ALTERATION OF A LOCAL HISTORIC DISTRICT (LHD) PROPERTY STAFF REPORT

Site: 59 Cross Street

Case: HPC.ALT 2023.21

HPC Meeting Date: July 18, 2023

Above: Existing site plan

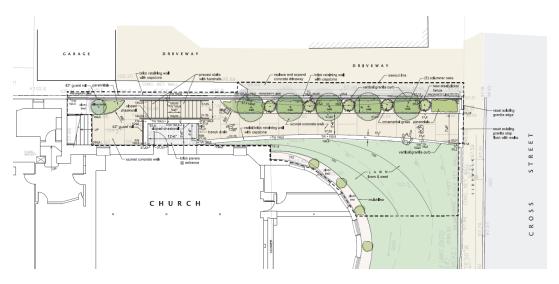
The Applicant proposes demolishing the existing sidewalk from Cross Street to the existing north entry at the basement, provide a new accessible ramp from the Cross Street sidewalk to the north side entry, demolish and rebuild the stairs to the right elevation entrance and rebuild the stairs and railing in a new configuration, expand the driveway on the right elevation, and demolish the existing north retaining wall along the abutting property. To summarize what this will look like, the proposal will remove the current stairs to the basement on the right elevation to provide an accessible ramp to the basement. The current stairs leading to the door on the right elevation facing the street will be demolished and rebuilt.

The Applicant's proposal is not consistent with the Design Guidelines on retaining the original layout and materials of walks, steps and paved areas. However, the proposed work will comply with the design guidelines in so much as they will improve site circulation by allowing better ADA accessibility and better and safer access by the public to the entrances of the structure. None of the proposed hardscape will affect the integrity of the building itself.

Above: Photo of existing canopy

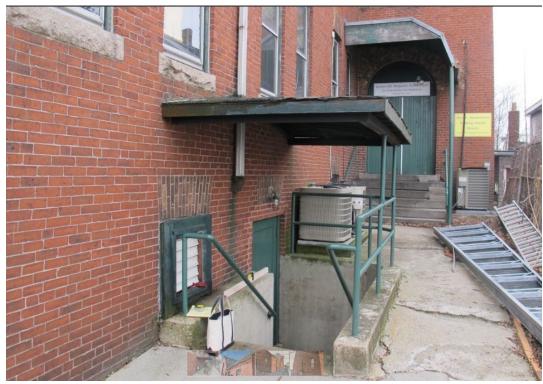
The Applicant proposes to remove the existing exterior steel canopy with a steel and glass canopy over the proposed new accessible basement entrance on the right elevation.

The Applicant's proposal to install a glass and steel canopy is mostly consistent with the Design Guidelines. The simple design will not detract from the architectural detailing of the building and the proposed awning will be consistent with the current use of the structure. The only way that the proposed work does not comply with the Design Guidelines is that the awning will be fastened to the brick, and while the awning can be later removed, the removal of the canopy will damage the brick.

Above: Existing right elevation depicting current door location

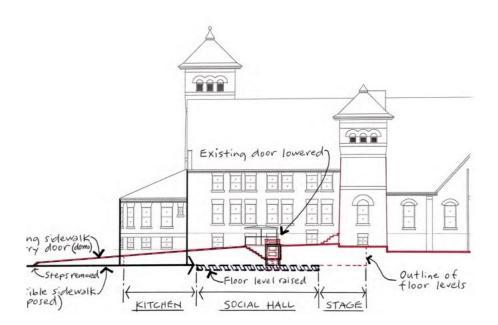
The Applicant proposes to relocate the existing basement door and doorframe at the right elevation basement entry; the basement door is to be placed two feet lower than it its current location. The applicant is also proposing to replace the large single window on the front elevation of the front tower. The Applicant proposes to replace the existing wood window with a new wood window and match the existing window in style, rails, and muntin profile.

The Applicant is proposing to lower the basement door and frame which is not consistent with the above cited design guideline stating that door openings should remain where they exist. That being said, the movement of the door and its frame will be minimally noticeable from the public right-of-way. The Applicant's proposal to replace the window on the tower may be compliant with the

Above: Proposed building section showing location of elevator shaft

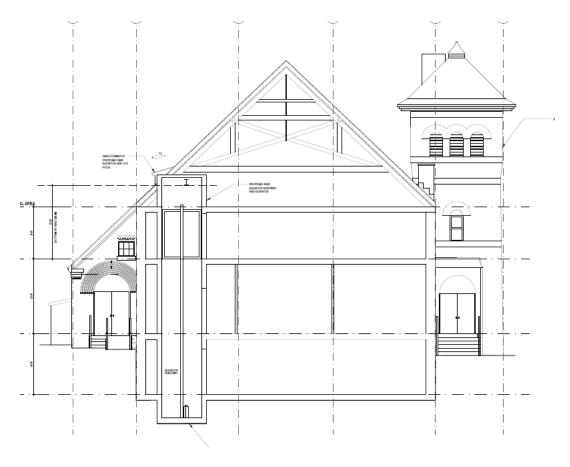
The Applicant proposes to install an elevator penthouse on the roof. The elevator itself will be located in the interior. The penthouse will be visible from the right of way; however, the only visible portion of the hoistway will be a shed dormer on the roof.

The proposal to install the elevator penthouse does not fully comply with the Design Guidelines on penthouses. The elevator hoistway is visible from the right-of-way. Staff does not know the proposed material for the shed dormer, but the Applicant should use slate roofing tile on the top of the shed dormer and a brick exterior on the wall of the shed dormer to best camouflage the penthouse from view. The use of these materials would comply with the requirement the Design Guidelines stating that the exterior treatment should relate in material and texture to the building.

While the elevator penthouse will be visible from the right-of-way the location of the elevator preserves the function of the main spaces within the interior of the building and allows the building to be ADA compliant. Additionally, the penthouse will be minimally visible through the use of the shed dormer.

- 1. The shed dormer of the elevator hoistway shall have a brick exterior.
- 2. The roof of the shed dormer shall be slate.
